ADDENDUM #2

PN PHS023-03RB1 – New Competition Pool at Pierce HS

August 18, 2023

1 POOL PLAN - ELECTRICAL
 E200 SCALE: 1/8" = 1'-0"

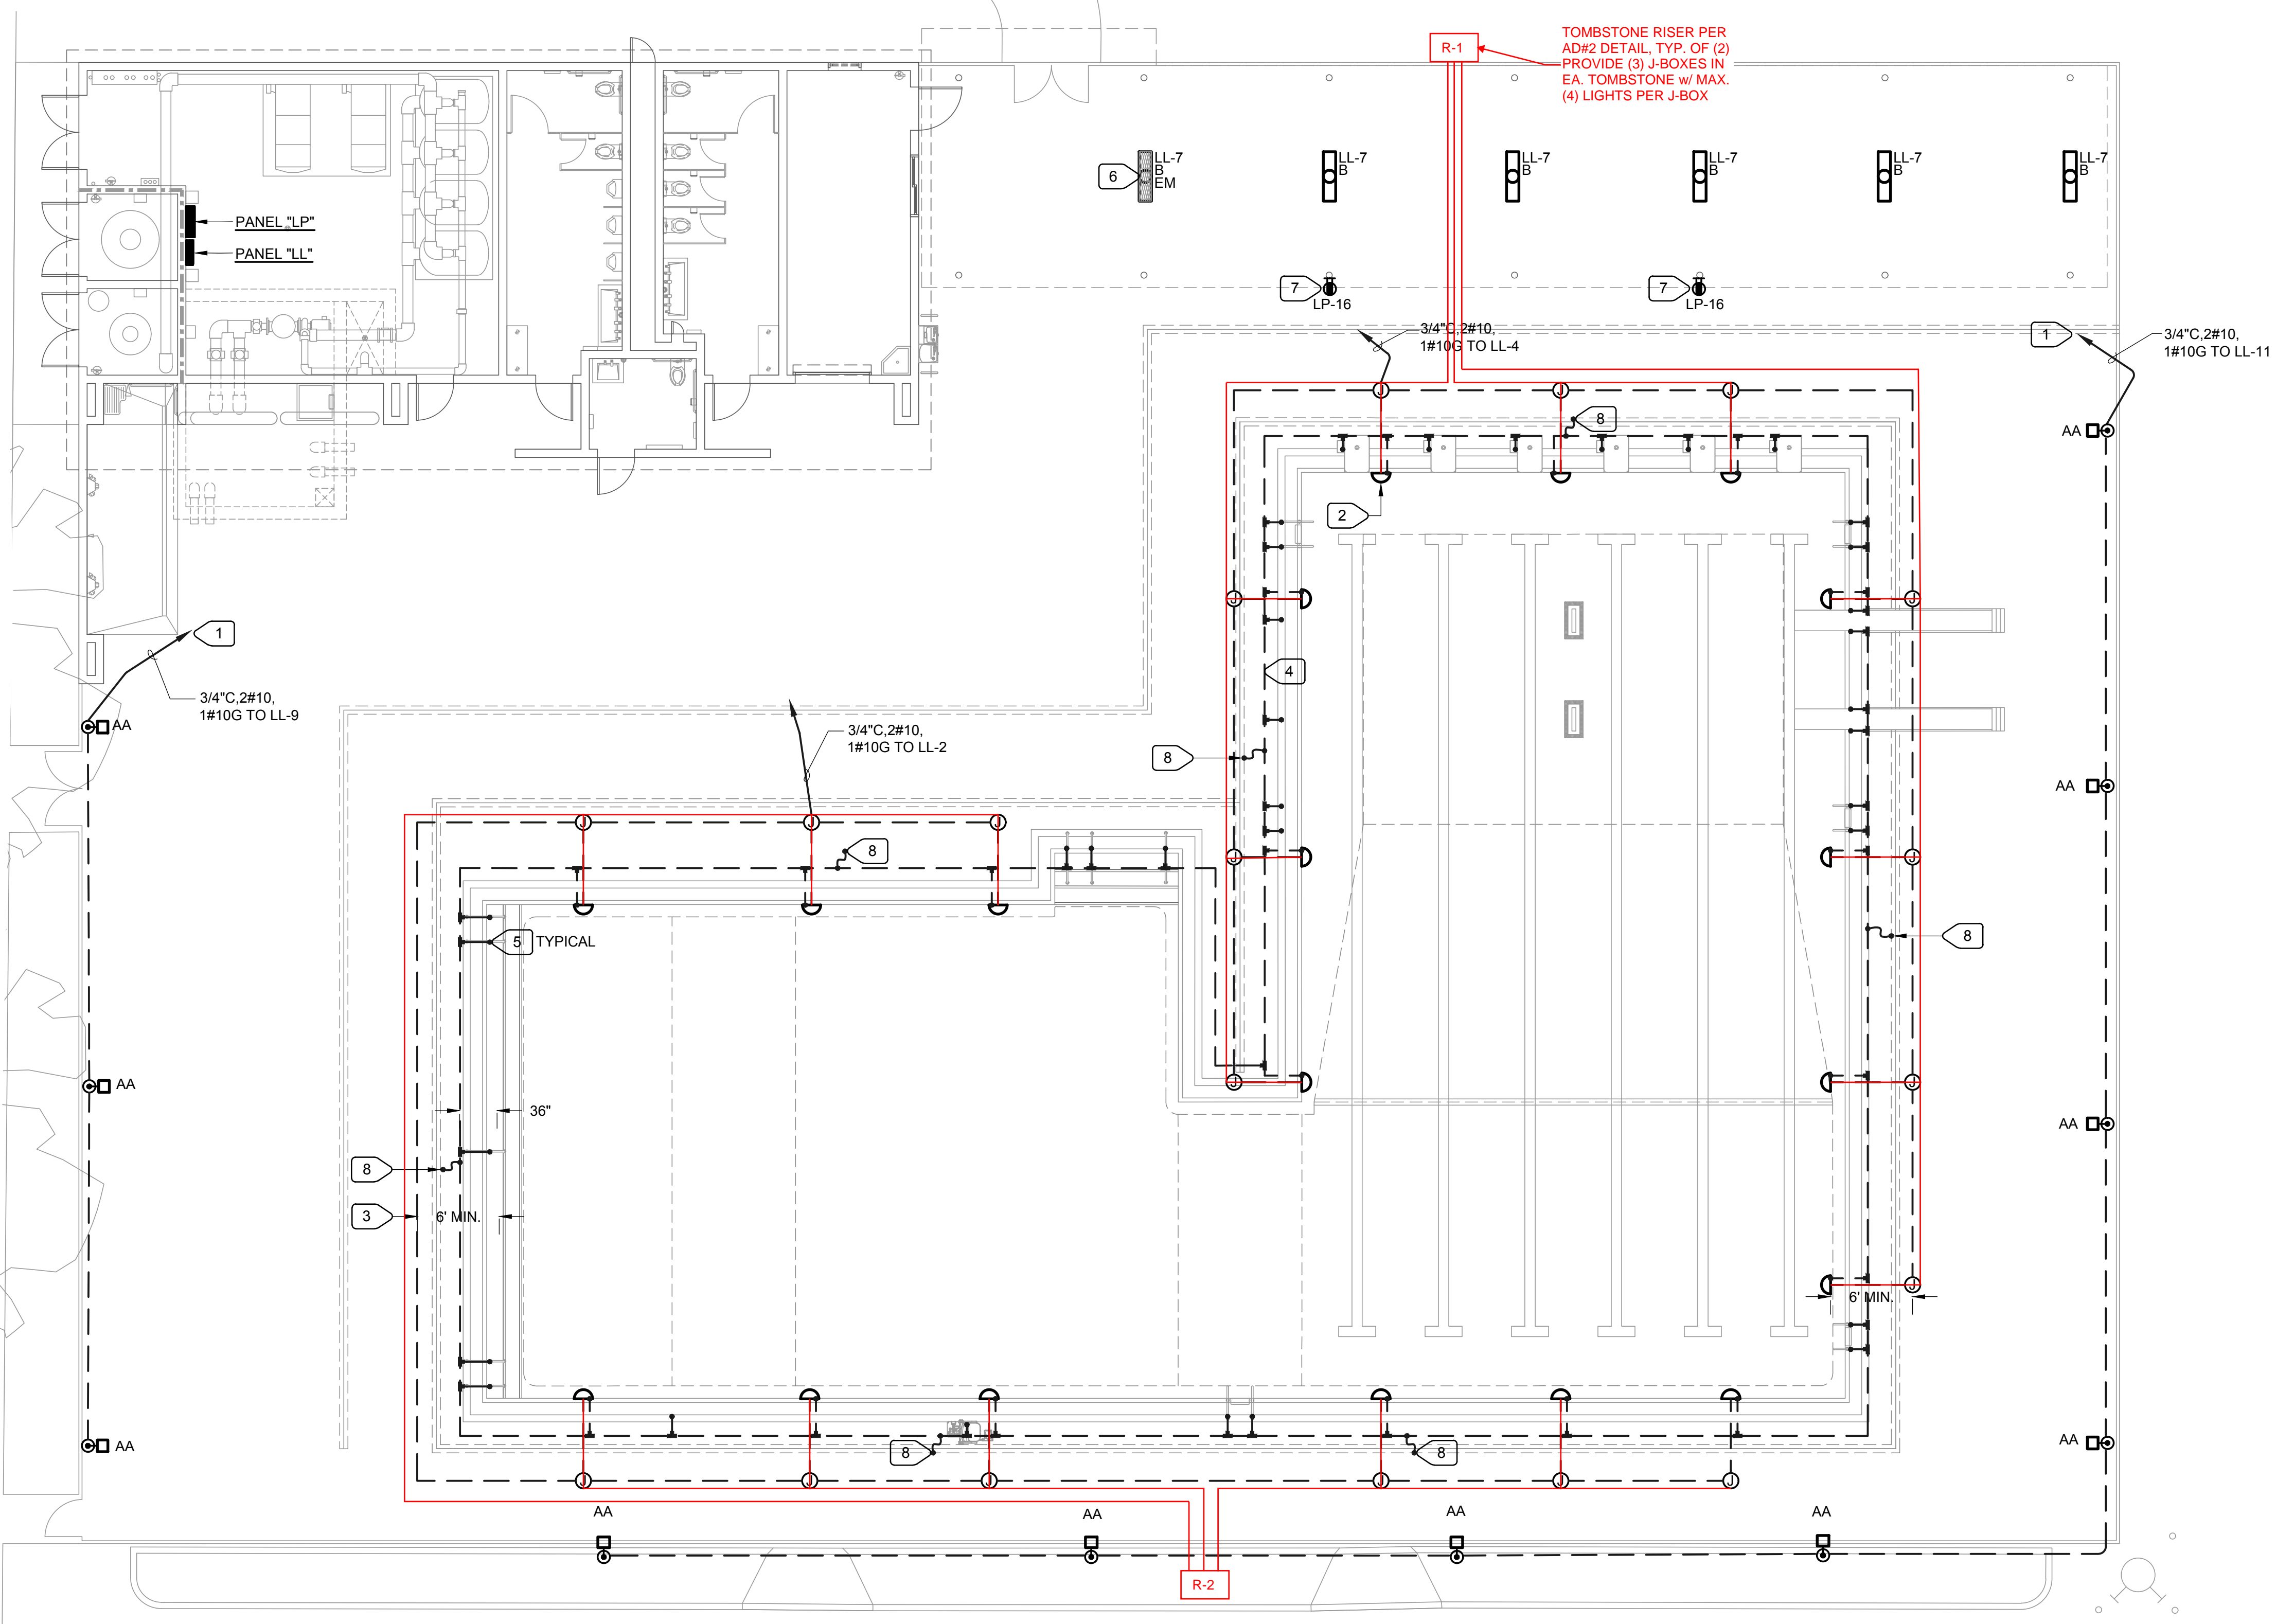
- a. Gutter gravity drainpipes and their link seals shall be 10" diameter.
5. Plan sheet SP.6 shows typical underwater light detail and UWL Junction Boxes mounted to wall or a bollard at 8" min above pool deck. However, Electrical sheet E200 shows multiple junction boxes (one per light) that appear to be flush mounted within the pool deck. Please provide qty of lights per JB, make/model of JB, and locations of pool UWL junction boxes required if they are to be mounted per Sheet SP.6 (8" above deck). Are the junction boxes to be mounted against the perimeter fencing and or against mech. room building? If so, do the JB's need to be mounted inside a concrete bollard or fixed to post that is 8" above the deck? If so, provide detail for UWL junction box bollards and their proposed locations that does not impede path of travel around the pool deck.

- a. Provide revised conduit routing shown on E200. In lieu of deck-mounted junction boxes, provide tombstone risers per attached detail.
- 6. Have the pool plans been approved by the Health Department?

R-1
 TOMBSTONE RISER PER
 AD#2 DETAIL, TYP. OF (2)
 PROVIDE (3) J-BOXES IN
 EA. TOMBSTONE W/ MAX.
 (4) LIGHTS PER J-BOX
